June 22, 2004

Re: **Addendum to Workplan for Additional Subsurface Investigation**  
Former Chevron Service Station # 20-6145  
800 Center Street  
Oakland, California  
Cambria Project No. 31E-2002

Subject: Fuel Leak Case RO000454, Former Chevron Station #20-6145, 800 Center St.,  
Oakland, CA 94607

**Site Plan with Proposed Soil Boring and Proposed CPT Boring Locations**

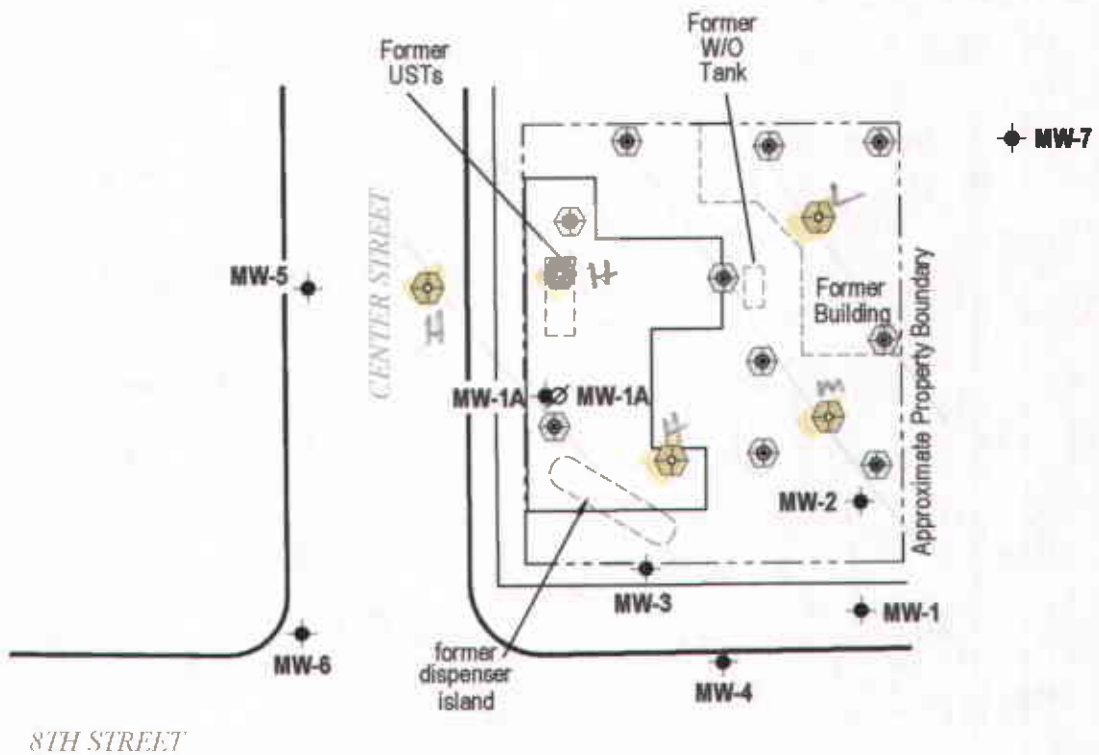
In accordance with your request, Cambria will collect depth-discrete soil and groundwater samples from five cone penetrometer test (CPT) borings. Cambria proposes advancing five CPT borings at the locations shown on Figure 2. Based on the CPT lithologic log, soil and groundwater samples will be collected at discrete zones.

The lateral definition of hydrocarbon impact in soil at the site is adequately defined along the western and southern sides of the property. Cambria proposes to advance one of the five CPT borings in Center Street, near previous boring P-2, to attain vertical definition. Three other proposed CPT borings will be located on-site near former soil borings which had high hydrocarbon impact at their greatest depth. Cambria has previously had difficulty obtaining encroachment permits from the City of Oakland. Based on known vertical and lateral hydrocarbon concentration data, Cambria will extrapolate on-site CPT data to the area near boring P-2 only if we cannot obtain an expedited encroachment permit from the City of Oakland. One other proposed CPT location will be located on-site in the northeastern corner of the property to delineate the extent of the hydrocarbon impact in that direction.

Our objective is to delineate vertical soil impact at the site and to define the soil-impact on-site in the northern and eastern sides of the property. To meet this objective, Cambria proposes to advance borings C-1 through C-5 with a CPT rig, and soil borings GP-31 through GP-40 with a direct push drill rig. Figure 2 shows the proposed locations of these soil borings. If results from this investigation suggest that additional groundwater monitoring wells are necessary, Cambria will propose the number, location, and construction of additional groundwater monitoring wells. The chemical analysis, site health and safety plan, utility location, soil disposal, and reporting will follow Cambria's *Workplan for Additional Subsurface Investigation*, dated April 6, 2004.
